4/23/03	Revised 6'x4' Culvert Extension Per Change Order
DATE	REVISION
STATE OF HAWAII DEPARTMENT OF TRANSPORTATION HIGHWAYS DIVISION DRAINAGE PLAN - 1 KAMEHAMEHA HIGHWAY RESURFACING Waiahole Valley Road to Crouching Lion Inn Federal Aid Project No. NH-083-1(43)	
Scale: 1" = 10'	Date: August 1, 2000
SHEET No. C-27 OF 65 SHEETS

KAMEHAMEHA HIGHWAY RESURFACING
Waiahole Valley Road to Crouching Lion Inn
Federal Aid Project No. NH-083-1(43)

FED. ROAD DIST. NO.	STATE	FED. AID PROJ. NO.	FISCAL YEAR	SHEET NO.	TOTAL SHEETS
HAWAII	HAW.	NH-083-1(43)	2001	C.O.34S-1	121

TYPICAL DETAILS OF TYPE 201214P GRATED DROP INLET

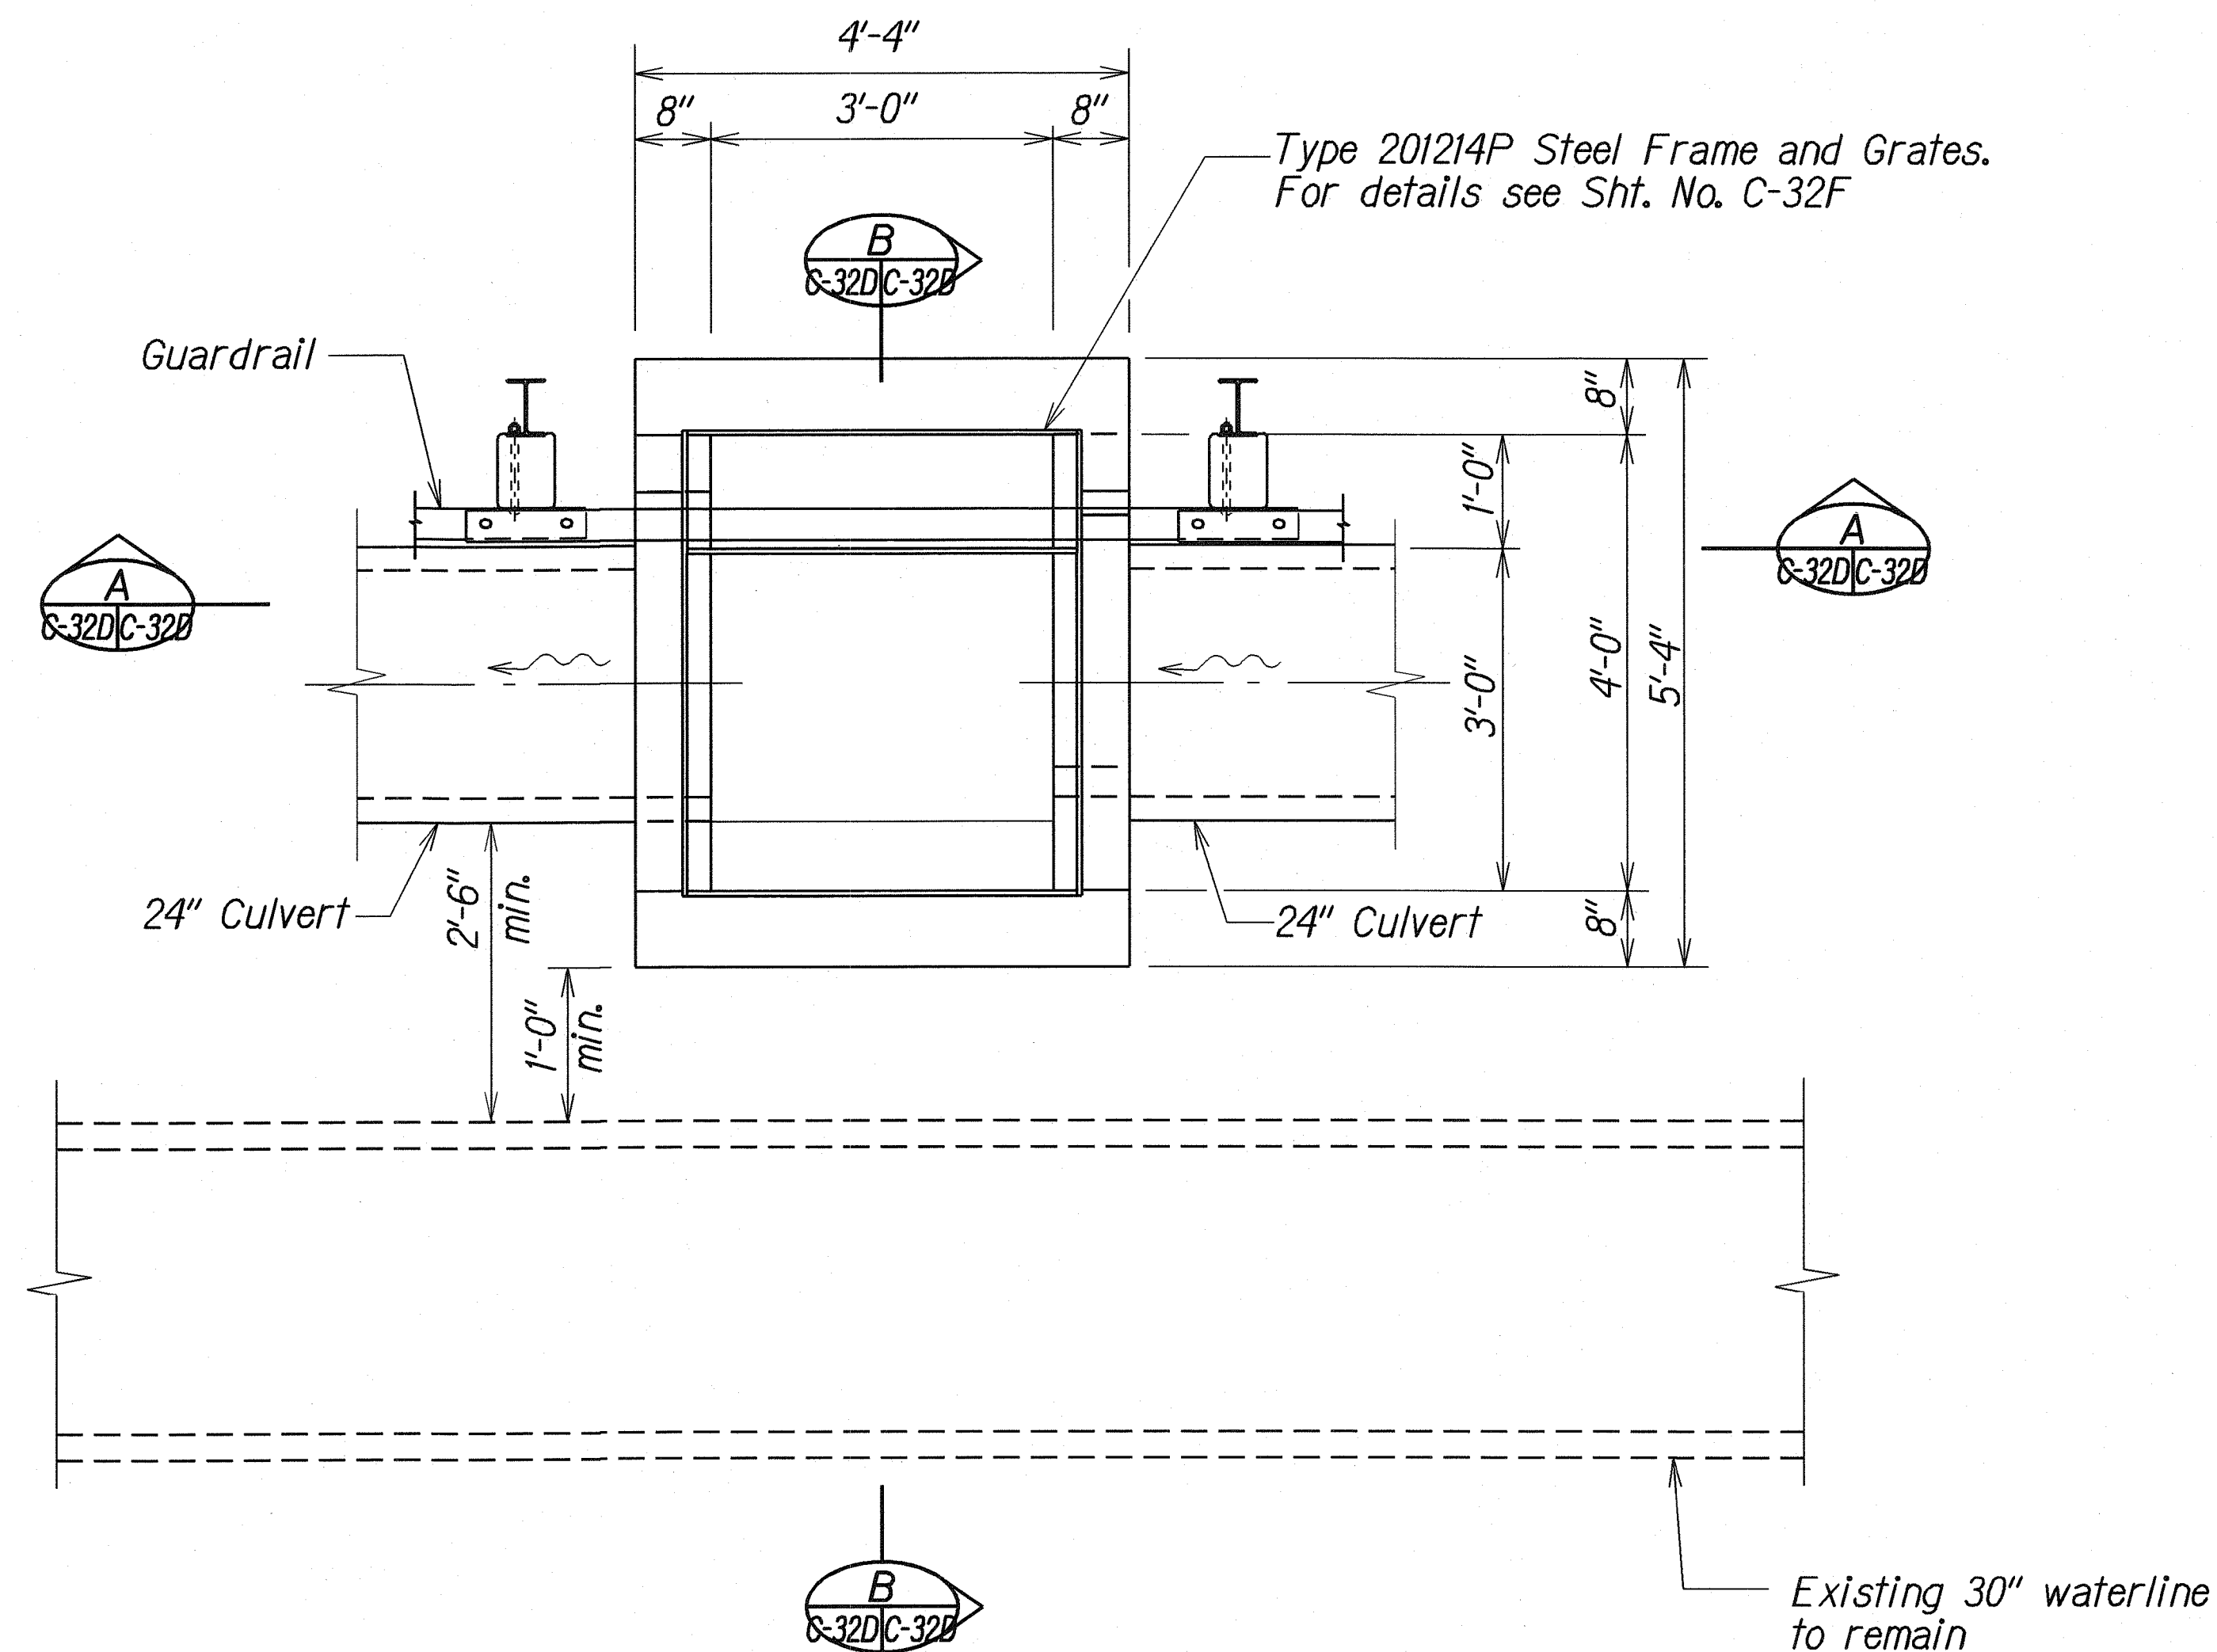
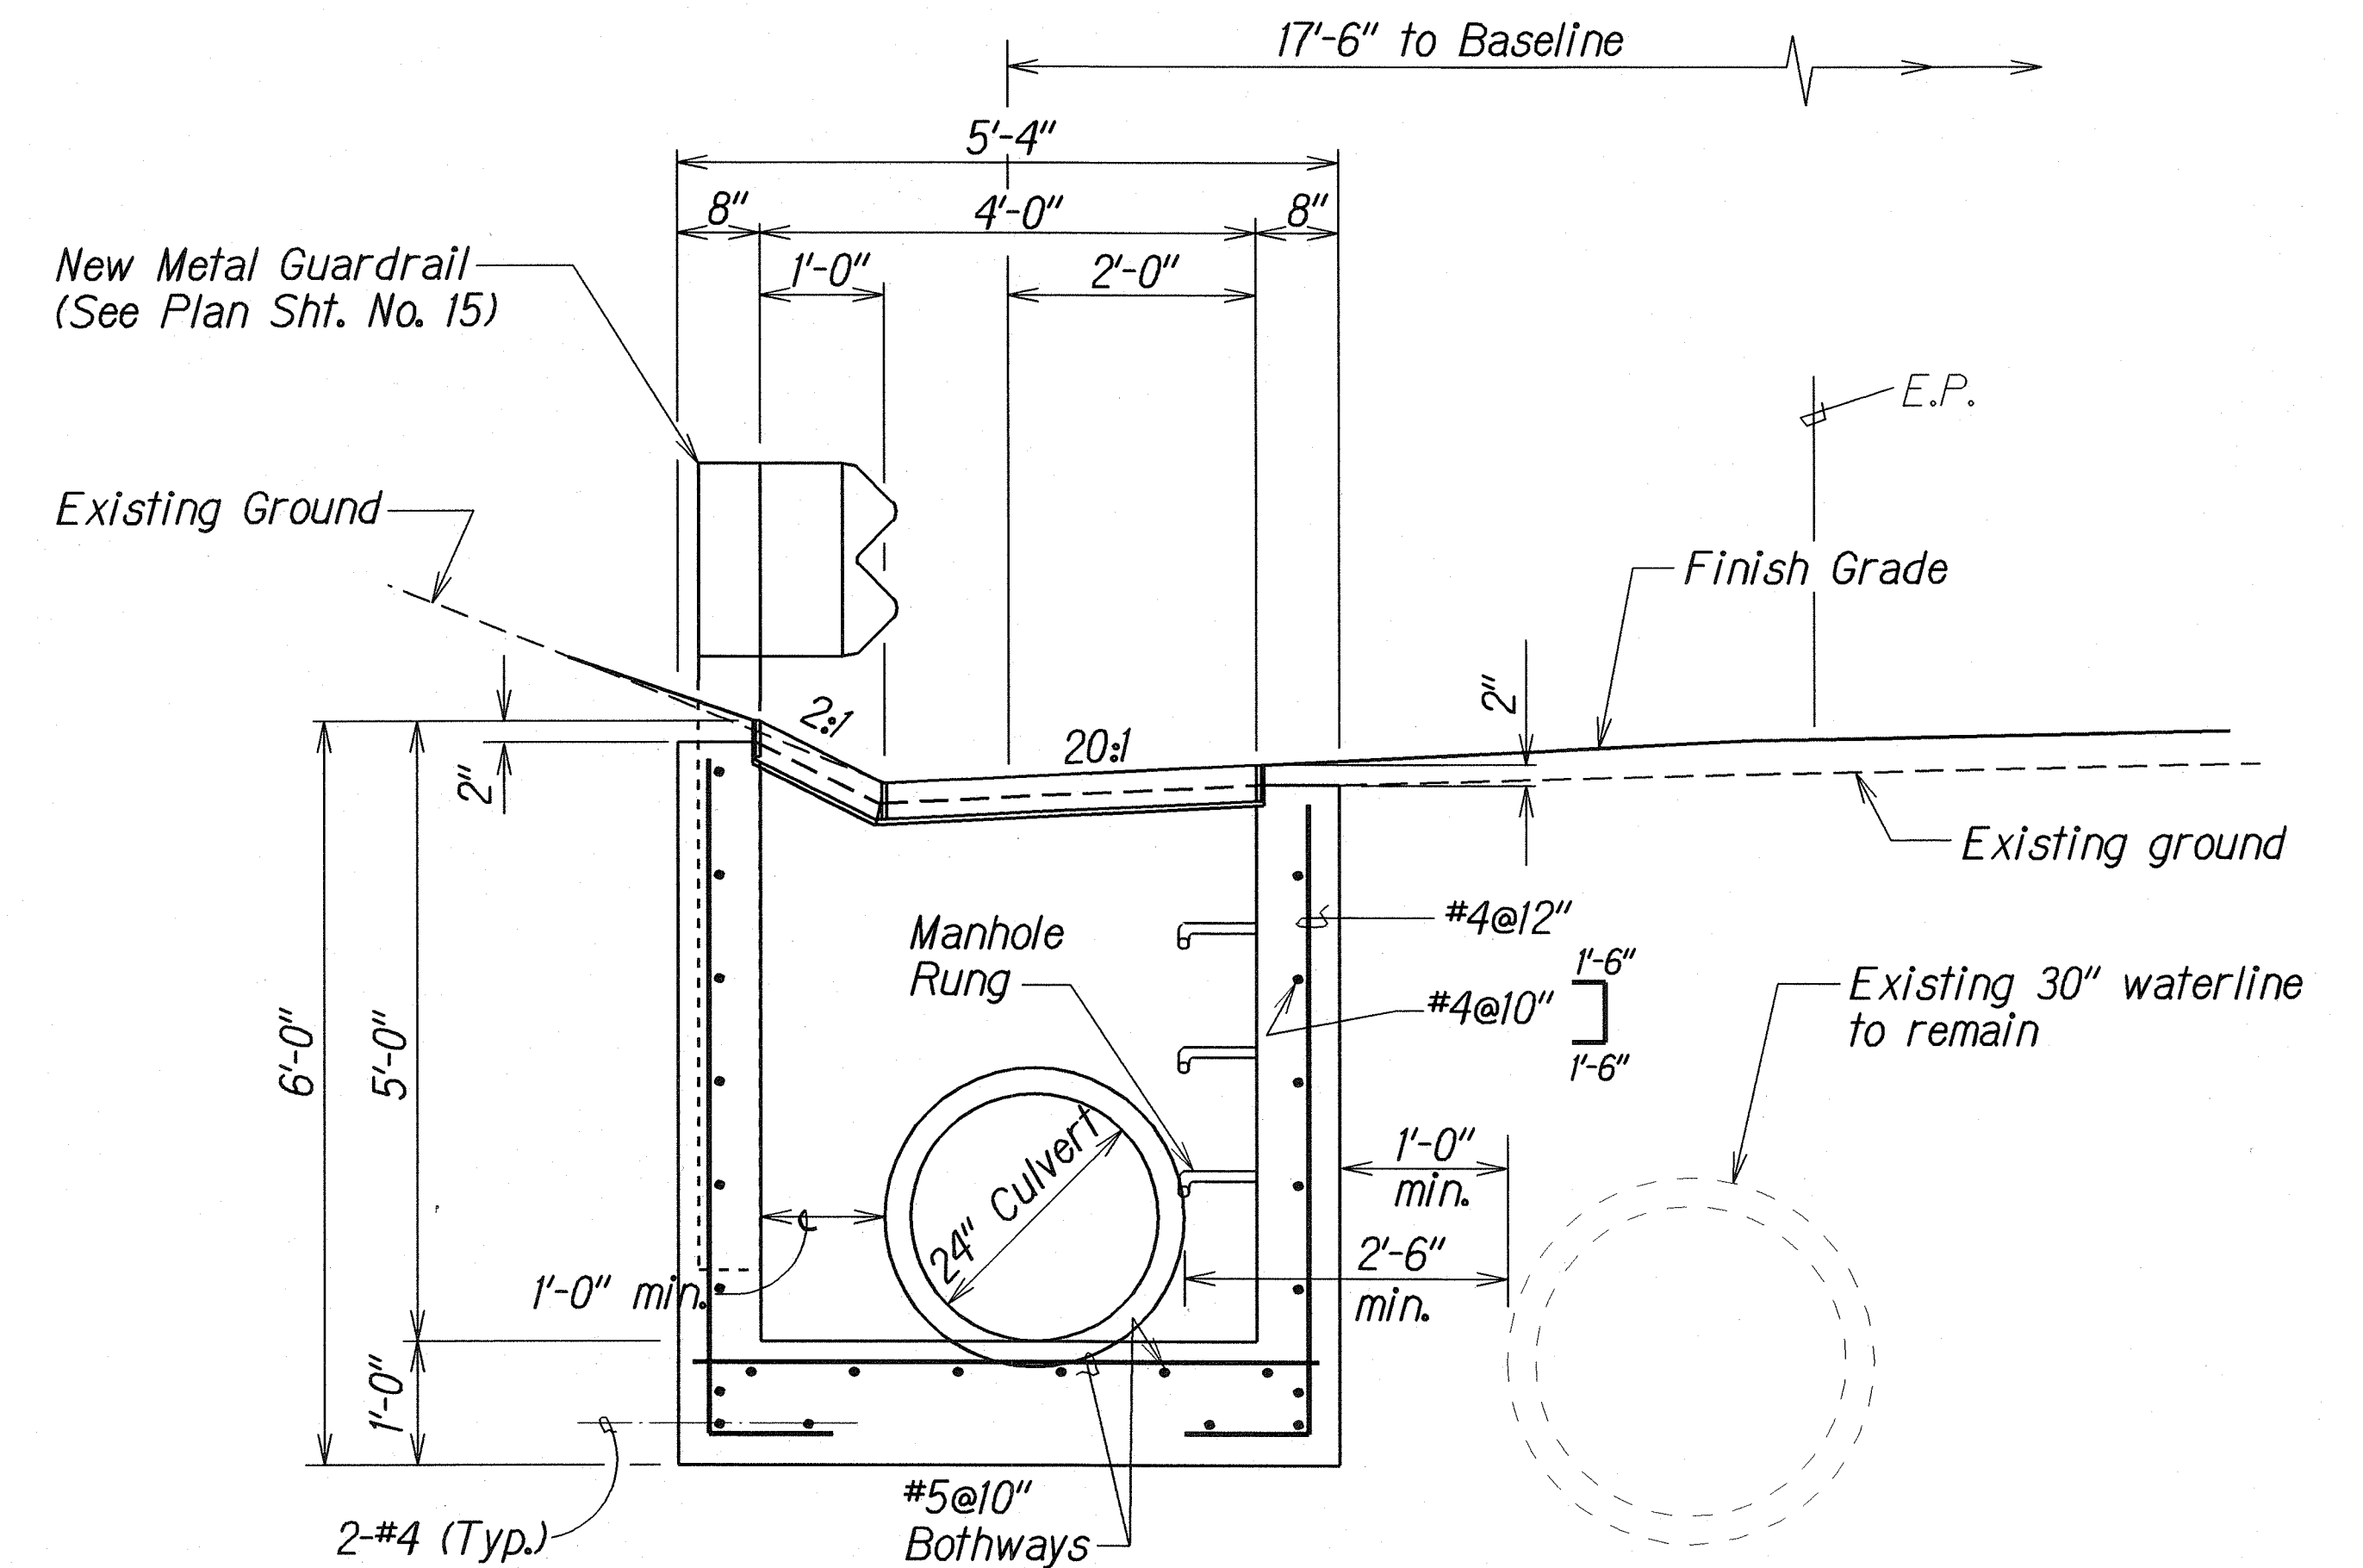
9/3/02	Add drainage detail of Type 201214P Grated Drop Inlet.
DATE	REVISION
STATE OF HAWAII DEPARTMENT OF TRANSPORTATION HIGHWAYS DIVISION DRAINAGE DETAILS KAMEHAMEHA HIGHWAY RESURFACING Waiahole Valley Road to Crouching Lion Inn Project No. NH-083-1(43) Scale: 3/4" = 1'-0" Date: Apr, 2002 SHEET No. C-32D OF 74 SHEETS
